# Engineering Change Notice

The following table contains a list of engineering changes that are not reflected in the Tsi381 Evaluation Board Schematics.

**Table 1: ECN for E2000\_AS001\_05 (Board order number Tsi381-RDK1 V2.0)**

# Tsi381 Evaluation Board Schematic

TITLE :			
<b>Tsi381 PCI INTERFACE</b>			
SIZE	DRAWING NUMBER :	Version:	DESIGNER :
<b>C</b>	60E2000_SC001_03	1.0	
LAST MODIFIED DATE :			SHEET
7-24-2007_17:06			5 OF 15

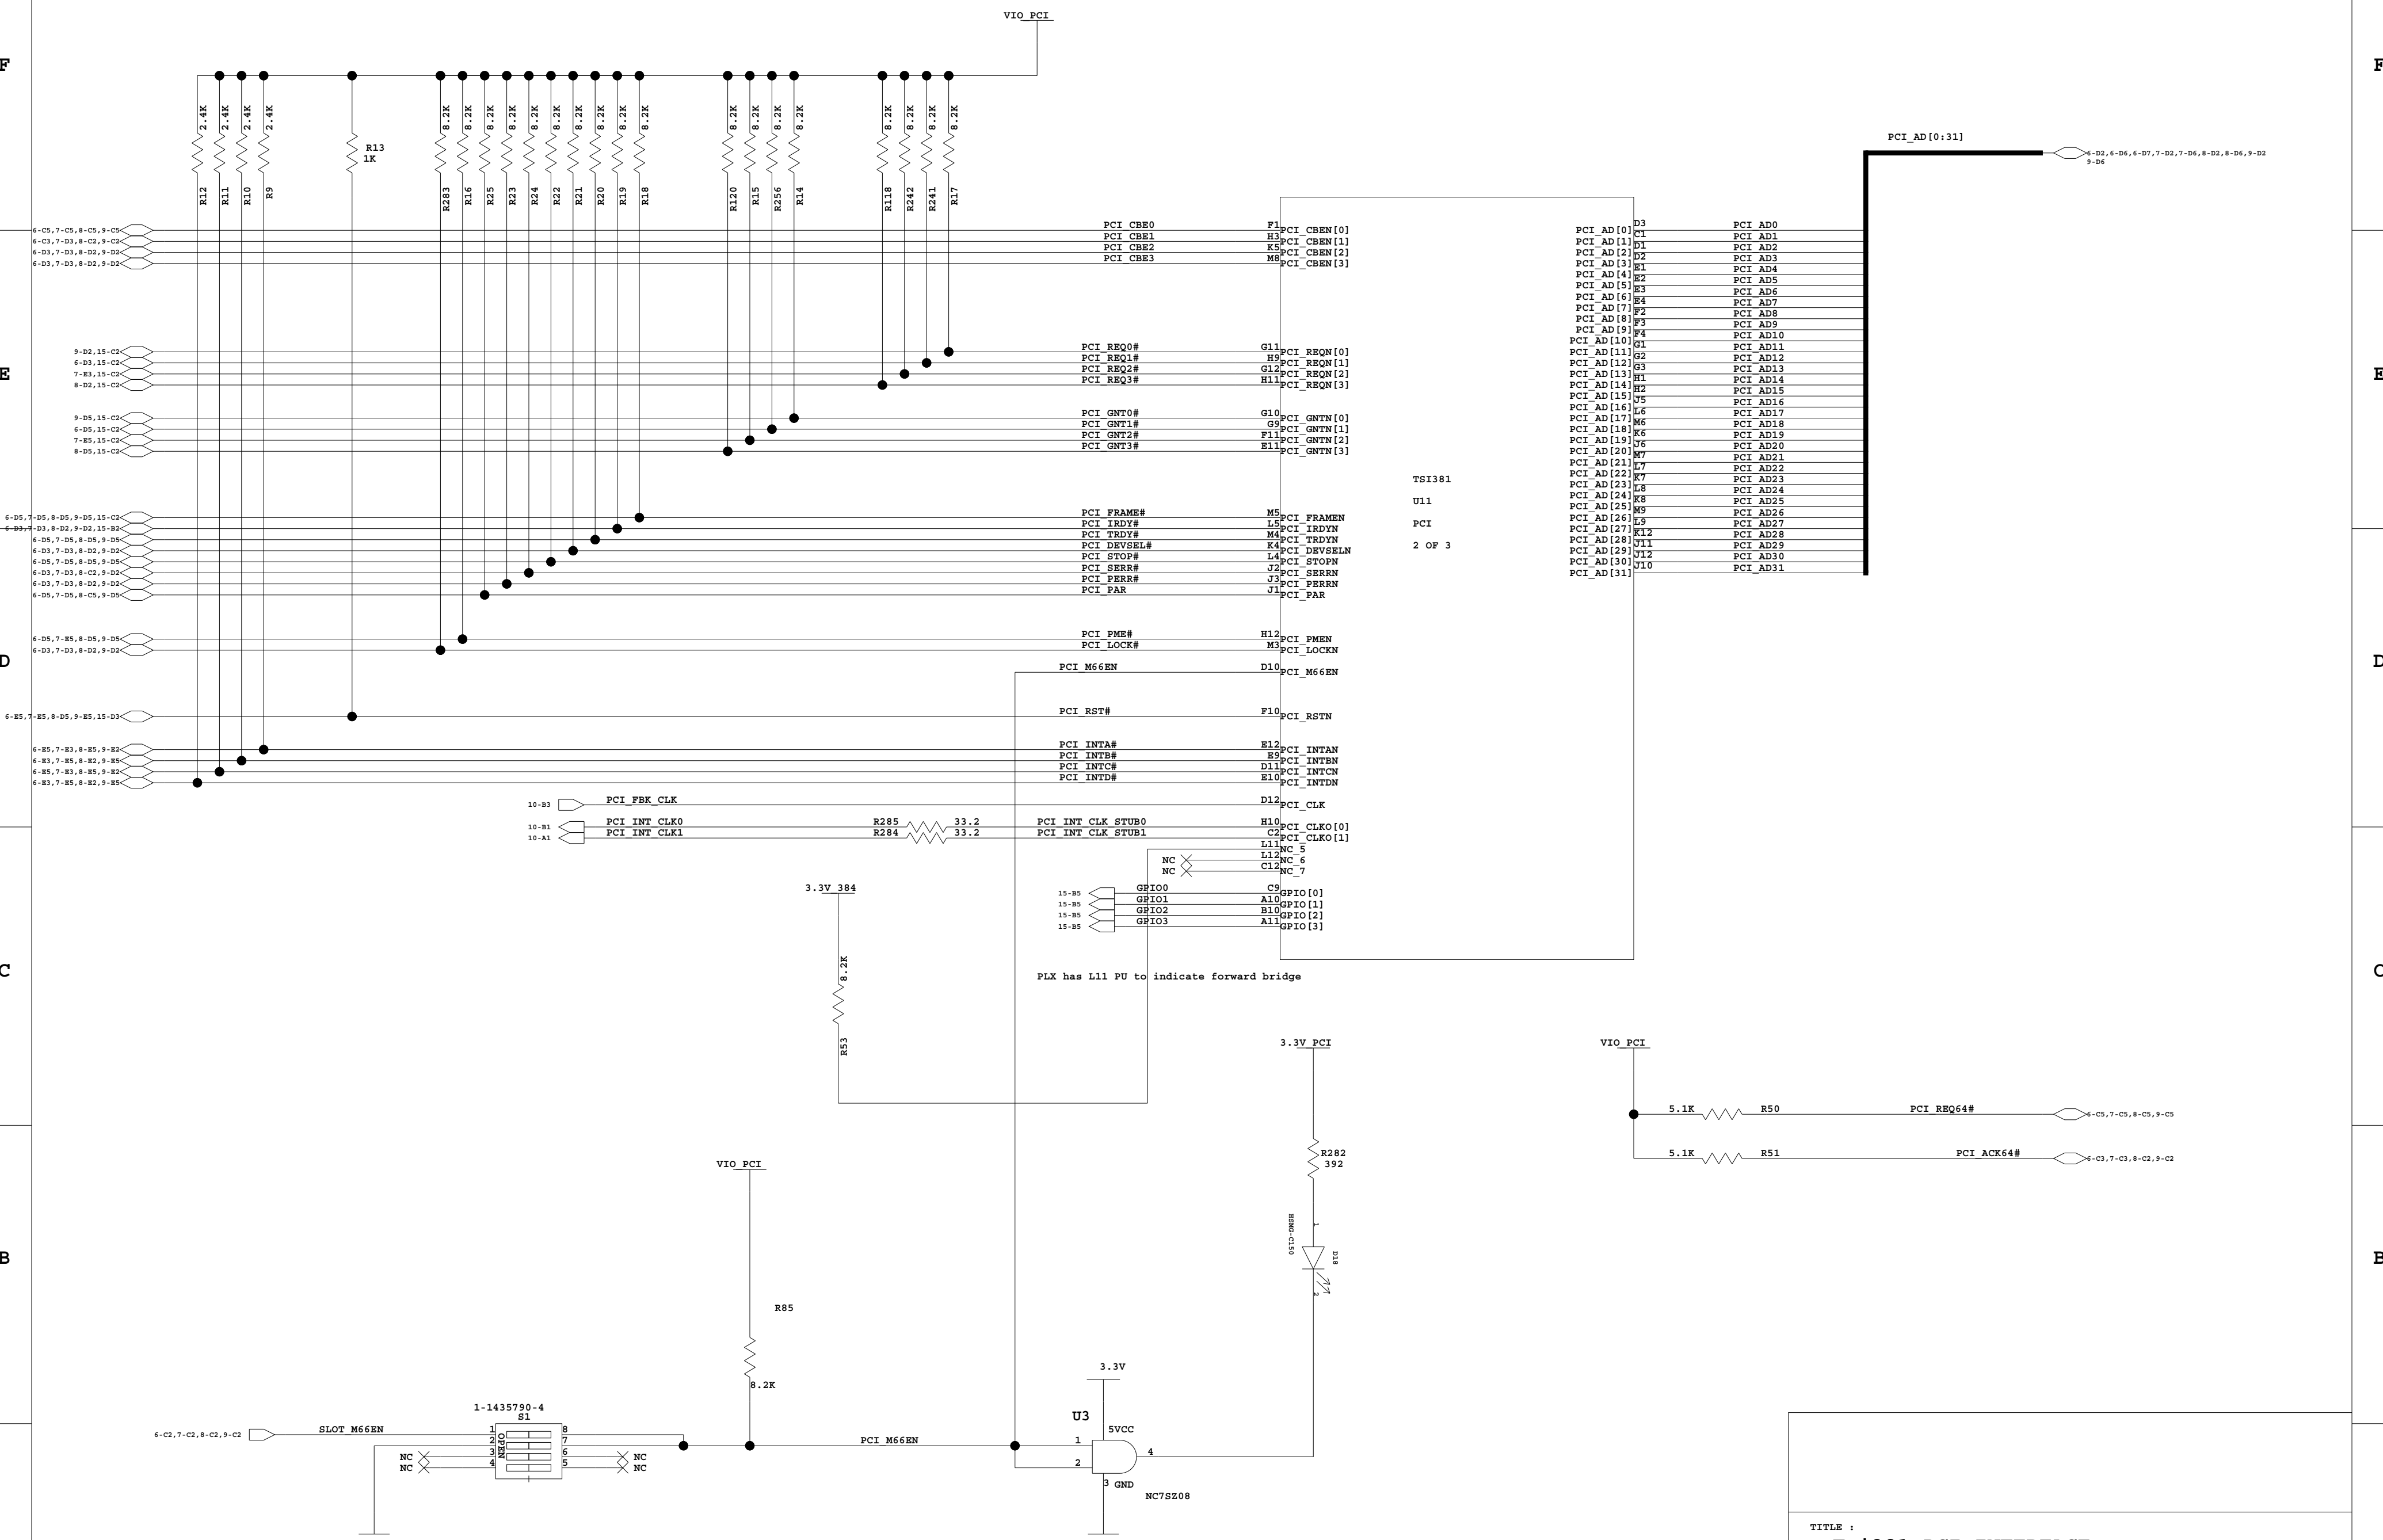
No.	Item(s)	Original	Change To
1	Tsi381 Device	Tsi381-66ILZ1	Tsi381-66ILZ2
2	3.3Vaux on J1, J2, J36, J37 <sup>a</sup>	No connection	Short pin A14 (3.3Vaux) to pin A16 (VIO_PCI) with 0-Ohm (0603) resistor

No.	Item(s)	Original	Change To
1	Tsi381 Device	Tsi381-66ILZ1	Tsi381-66ILZ2 <sup>a</sup>
2	3.3Vaux on J1, J2, J36, J37 <sup>b</sup>	No connection	Short pin A14 (3.3Vaux) to pin A16 (VIO_PCI) with 0-Ohm (0603) resistor

a. Ball K1 was removed from the Tsi381 device to allow the TEST\_SPARE[2] signal to be detected as logic high. This version of the evaluation board is intended to support applications that require PCI bus parking on the Tsi381.

TITLE :			
PCI SLOT 0			
SIZE	DRAWING NUMBER :	Version:	DESIGNER :
C	60E2000_SC001_03	1.0	
LAST MODIFIED DATE :			SHEET
7-25-2007_15:13			6 OF 15

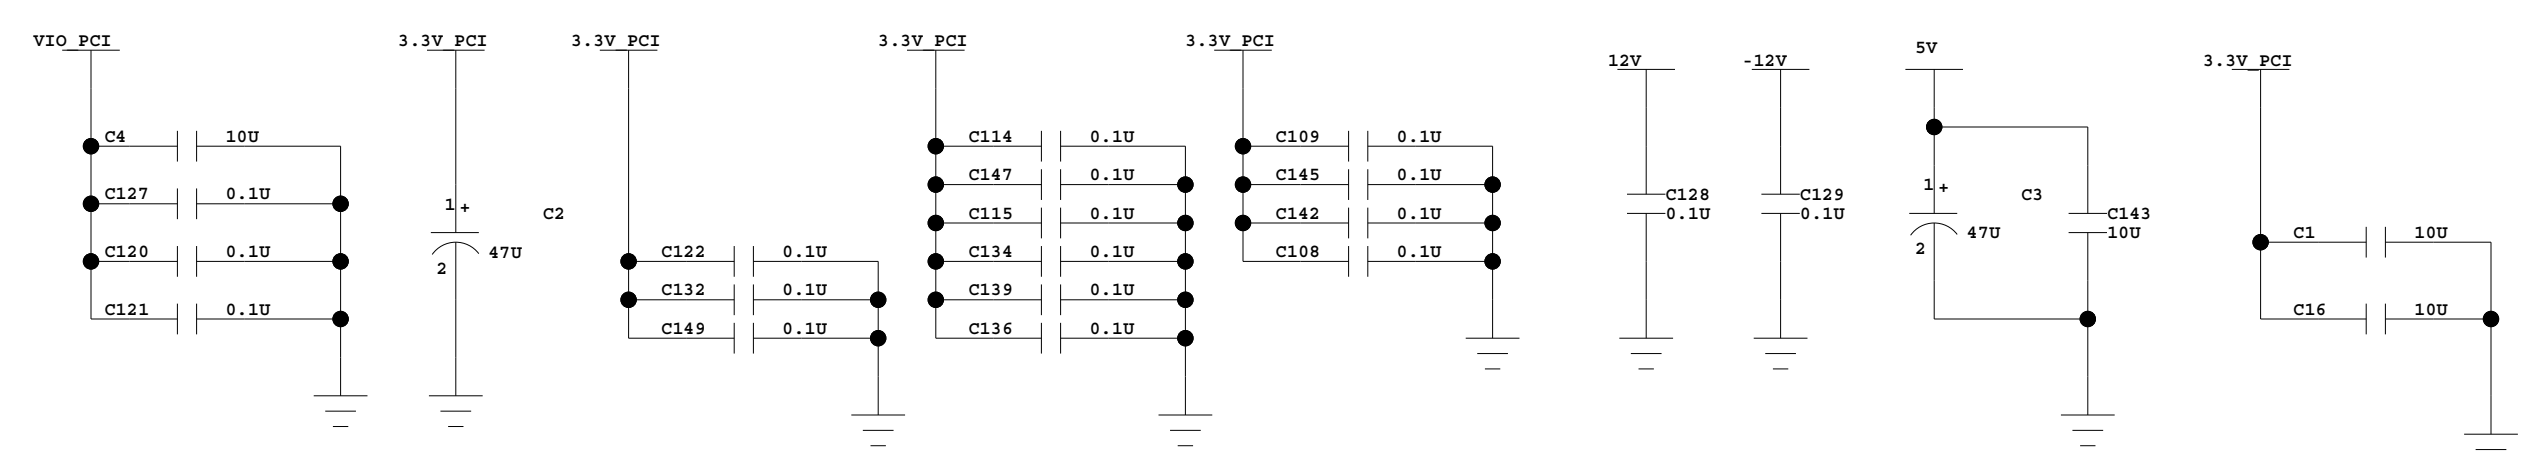
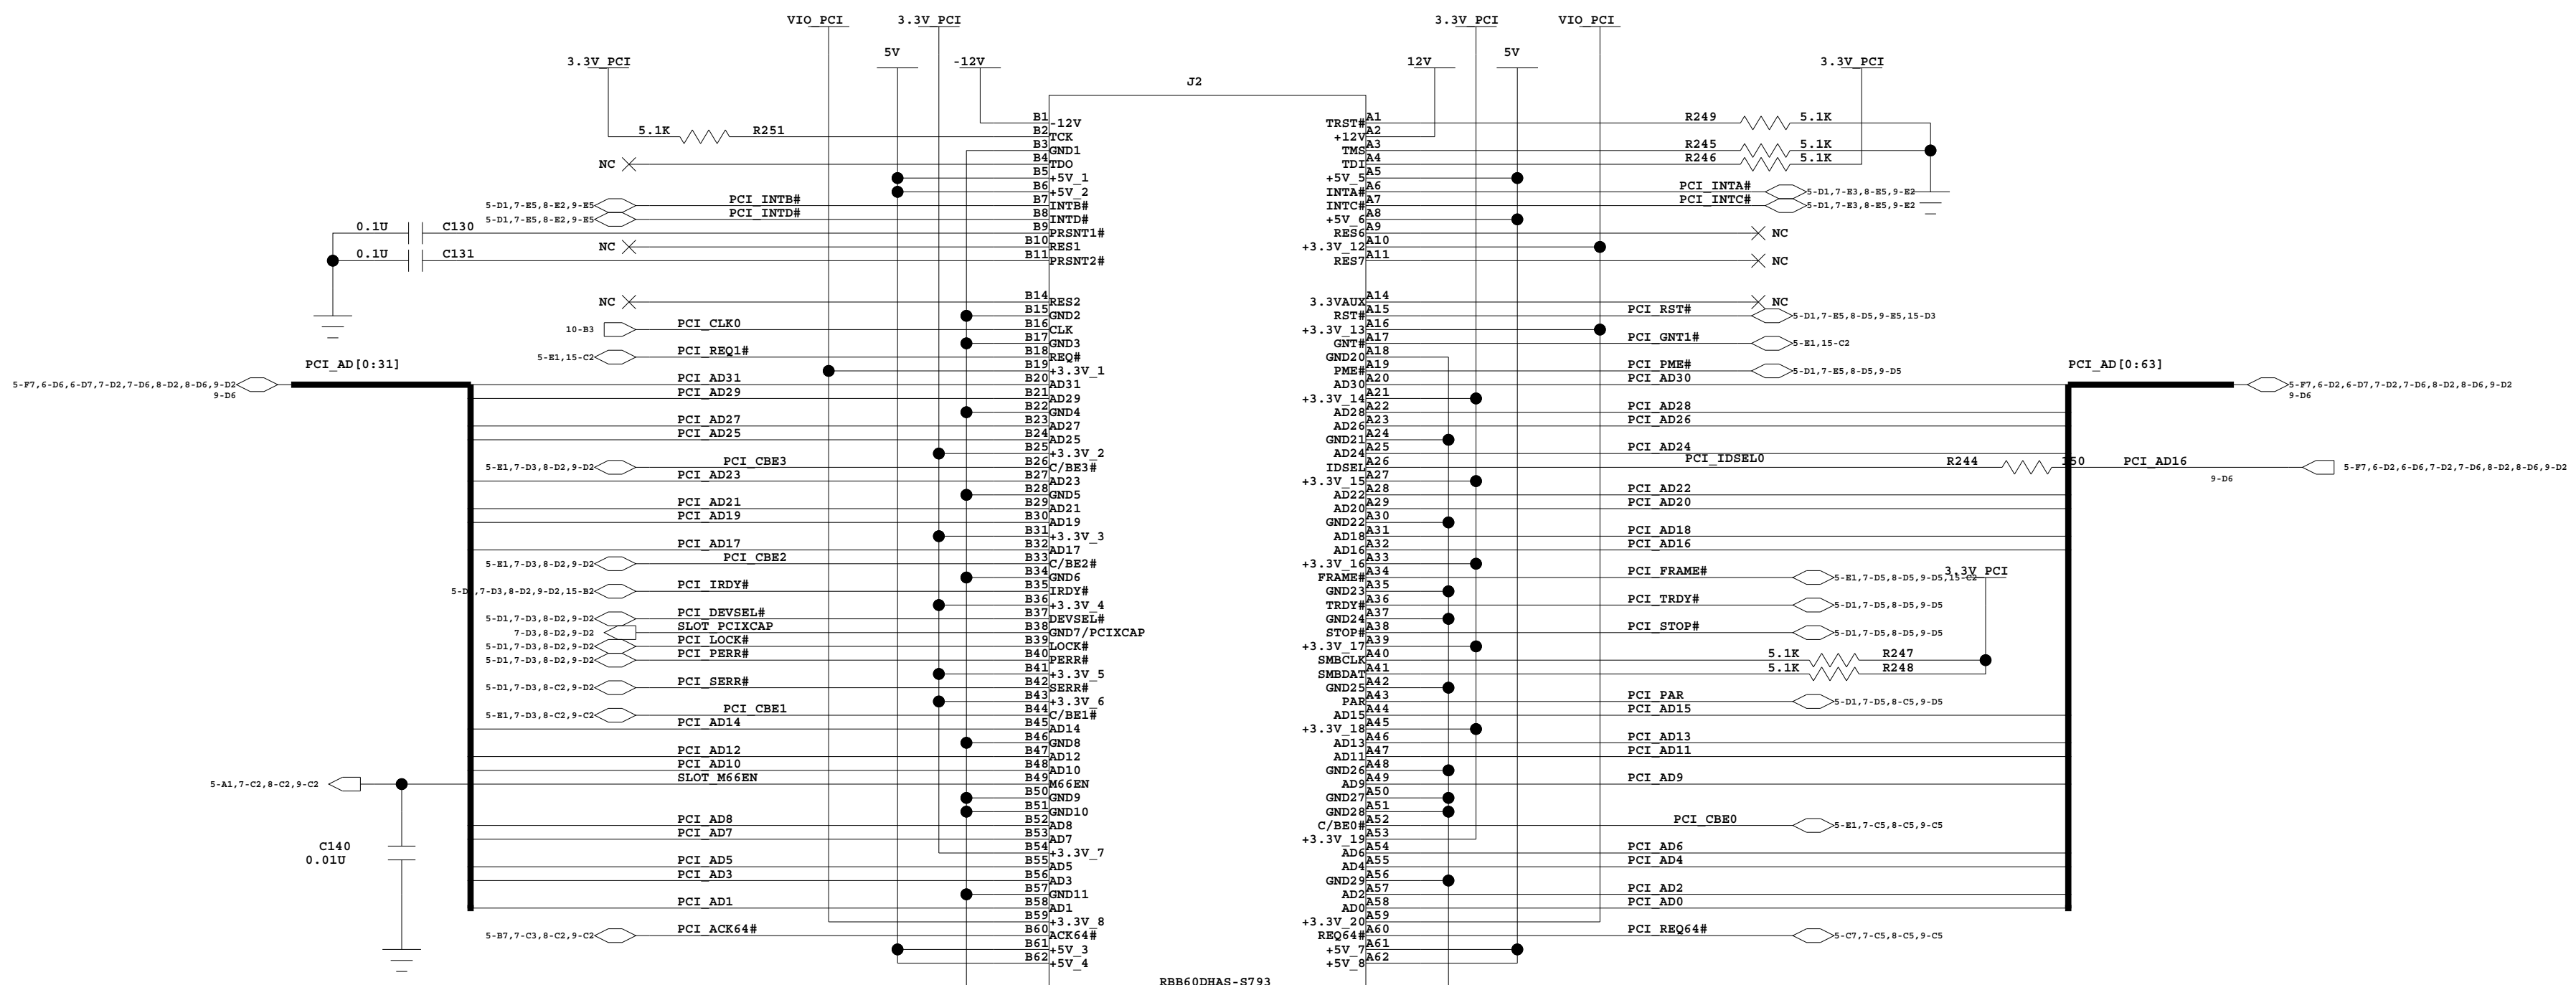
a. 3.3Vaux does not provide power to plug-in cards when the system is powered down.

b. 3.3Vaux does not provide power to plug-in cards when the system is powered down.
